SUBJECT: Addendum No. 2  
Hiwassee Utility Commission, Charleston, TN  
Water Treatment Plant Filters 1 – 4 Rehabilitation and Improvements

**ADDENDUM NO. 2**

**CONTRACT DOCUMENTS, SPECIFICATIONS, AND DRAWINGS  
FOR THE  
WATER TREATMENT PLANT  
FILTERS 1 – 4 REHABILITATION AND IMPROVEMENTS**

JOB NO.  
K21011  
ISSUE DATE  
3-30-22  
DRAWING NO.  
104

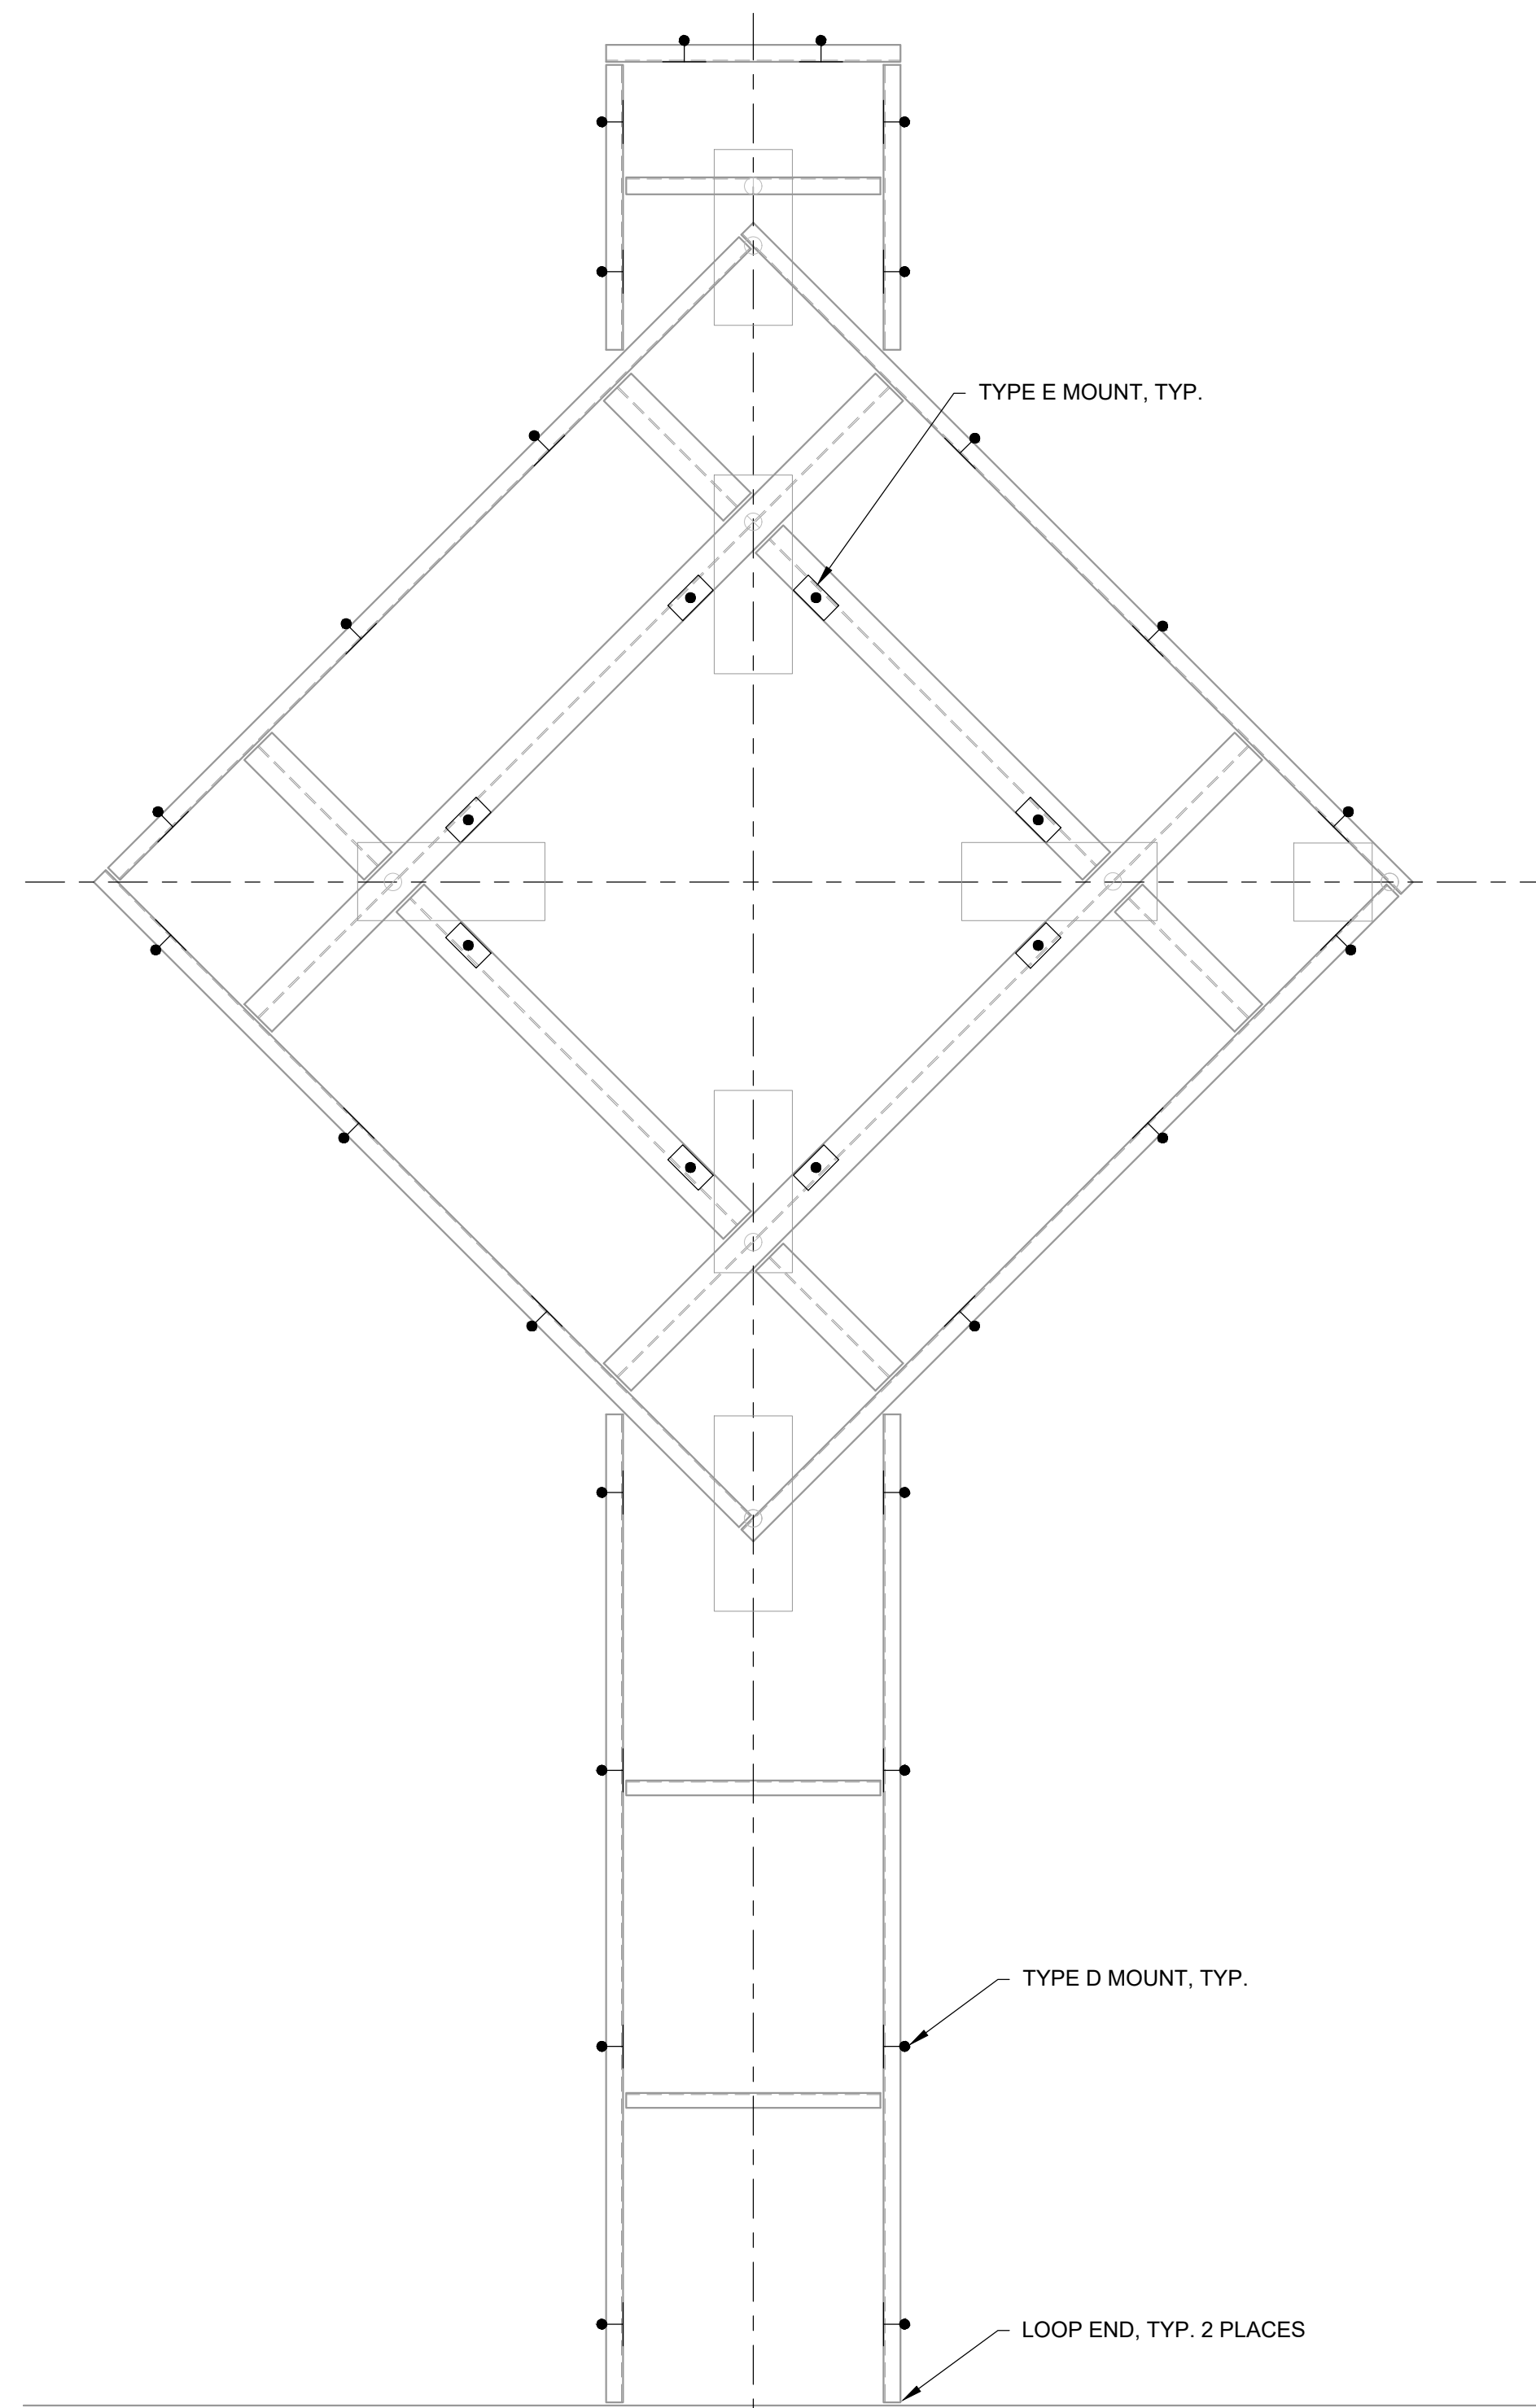
REVISIONS		DATE		BY		APPD	
NO.	DESCRIPTIONS	DATE	BY	PKG	KIL	PKG	KIL
1	CHANGED WALKWAY SYSTEM	5/30/23

**HIVASSEE UTILITIES COMMISSION**  
**WATER TREATMENT PLANT**  
**FILTERS 1-4 REHABILITATION AND IMPROVEMENTS**  
**WALKWAY PLATFORM AND**  
**GUARDRAIL REPLACEMENT**  
**SHEET 2 OF 2**

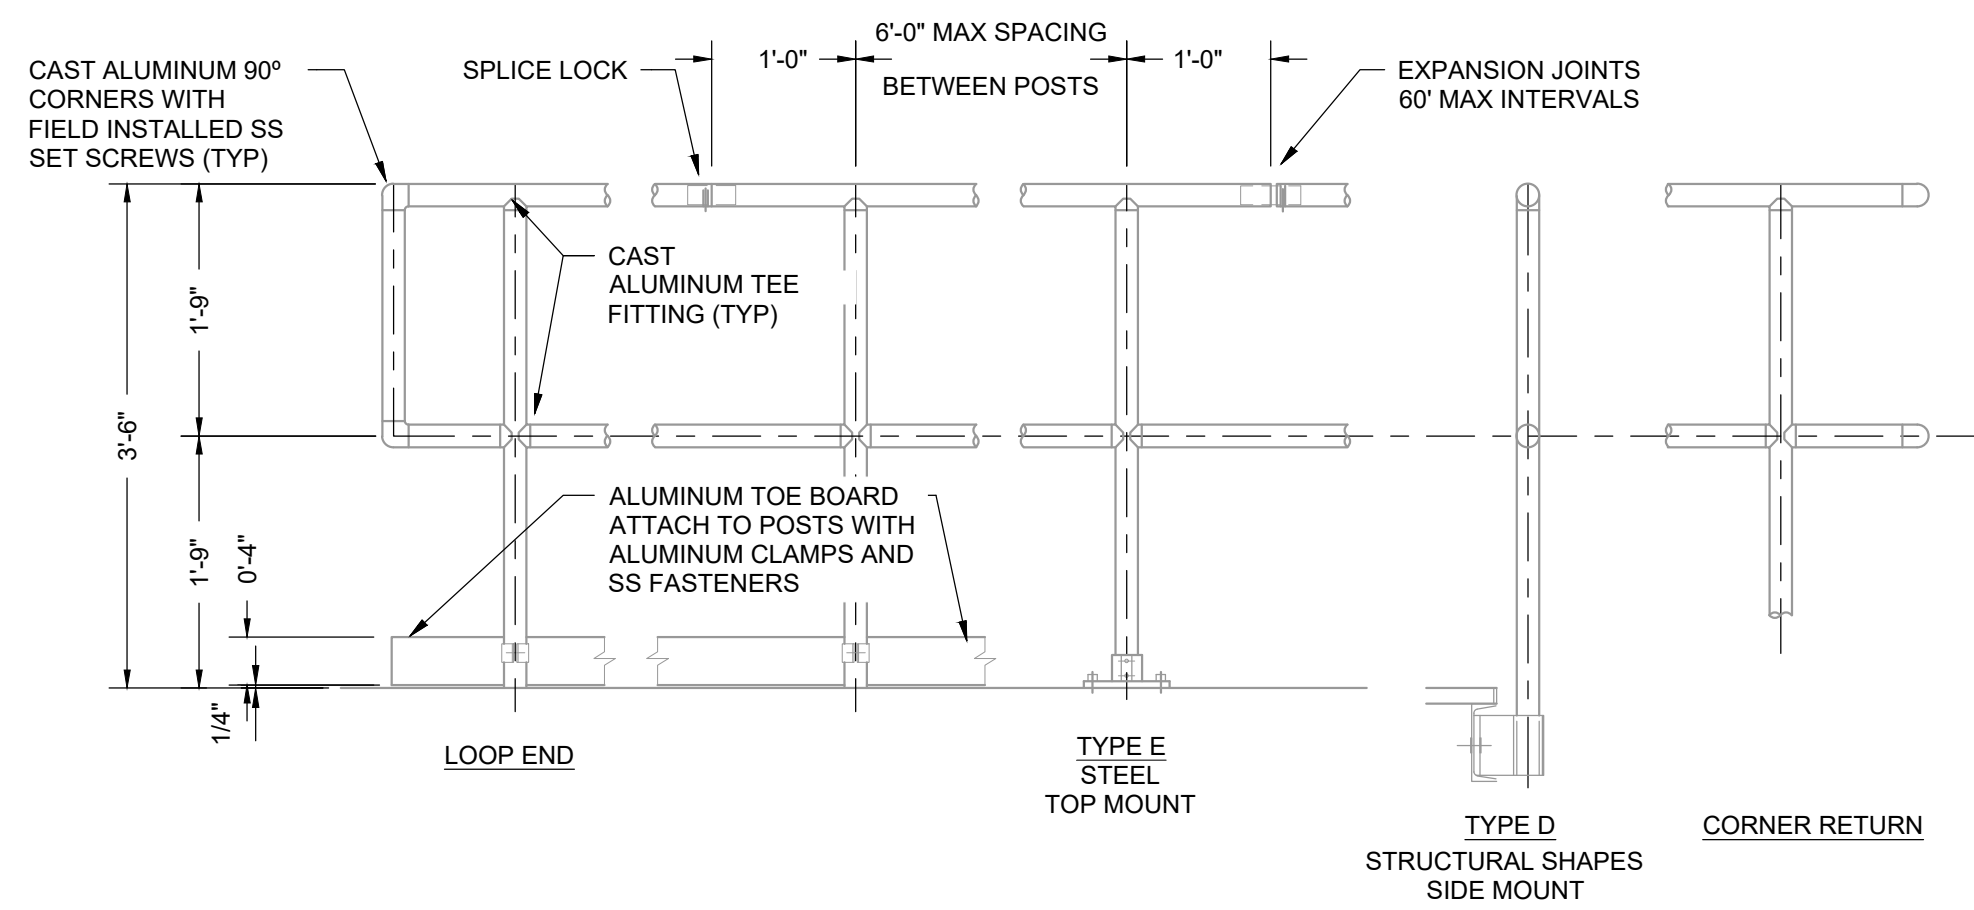
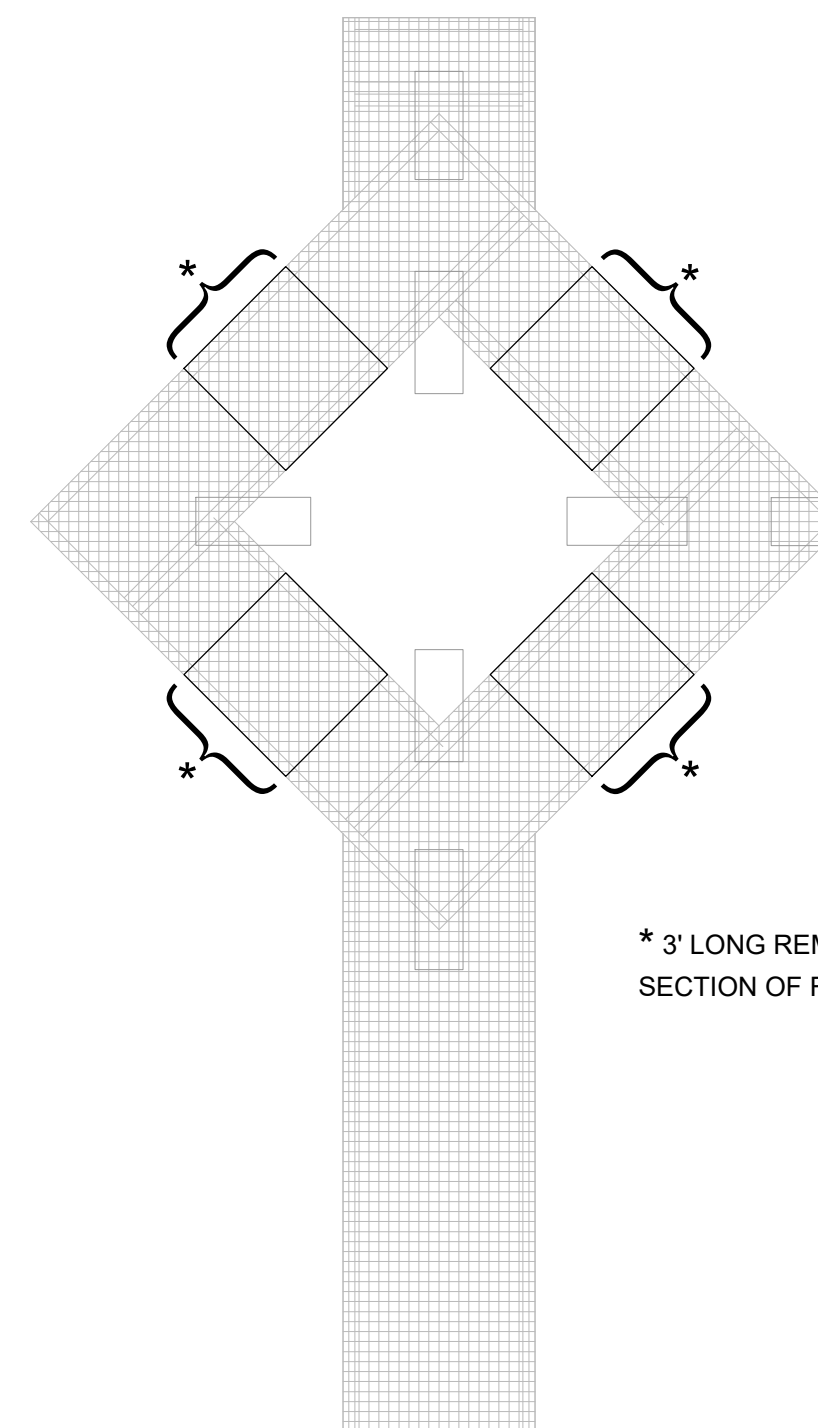
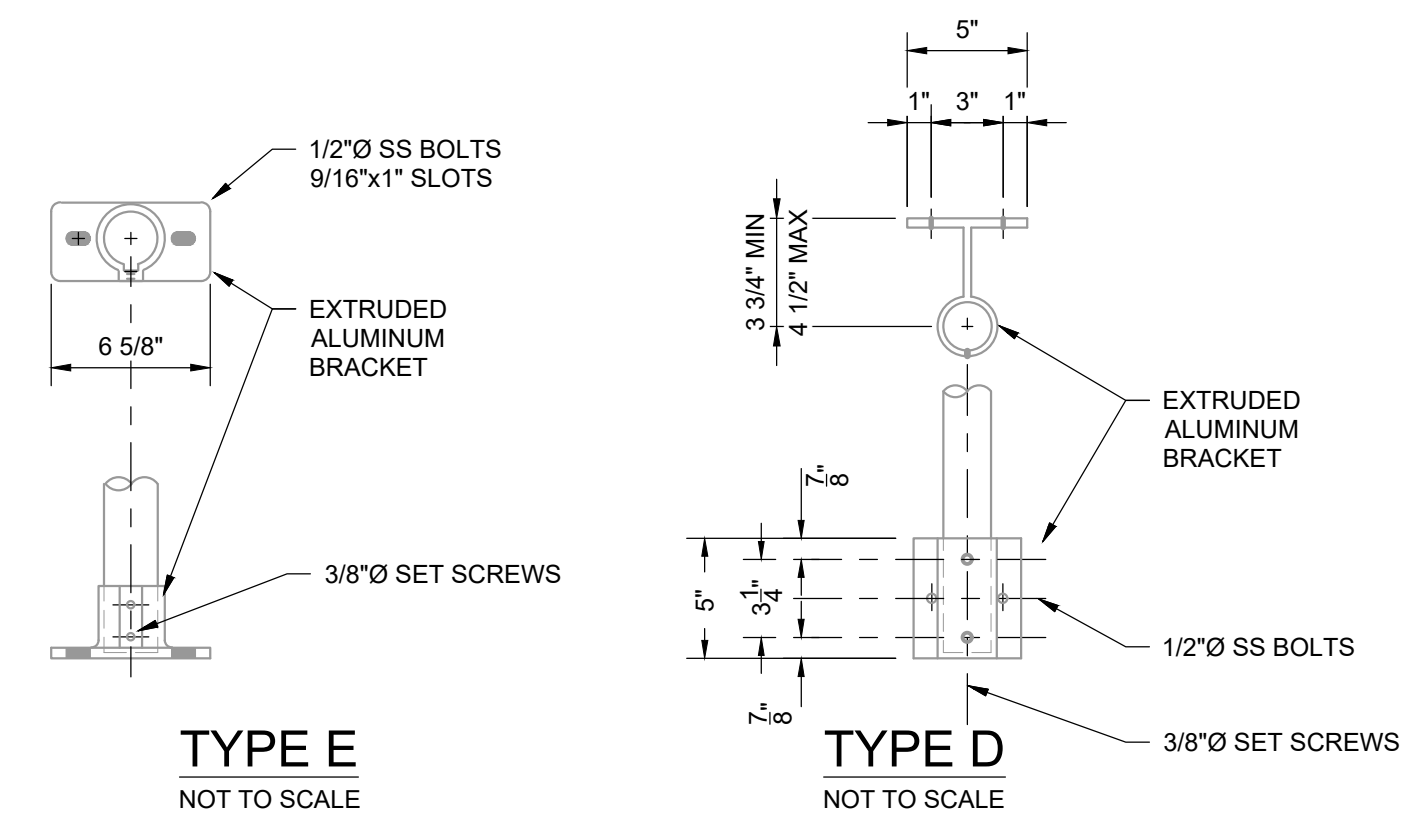
REVISIONS		DATE	BY	APPD
NO.	DESCRIPTIONS	PKG	KIL	KIL
1	CHANGED GUARDRAIL SYSTEM	5/30/23
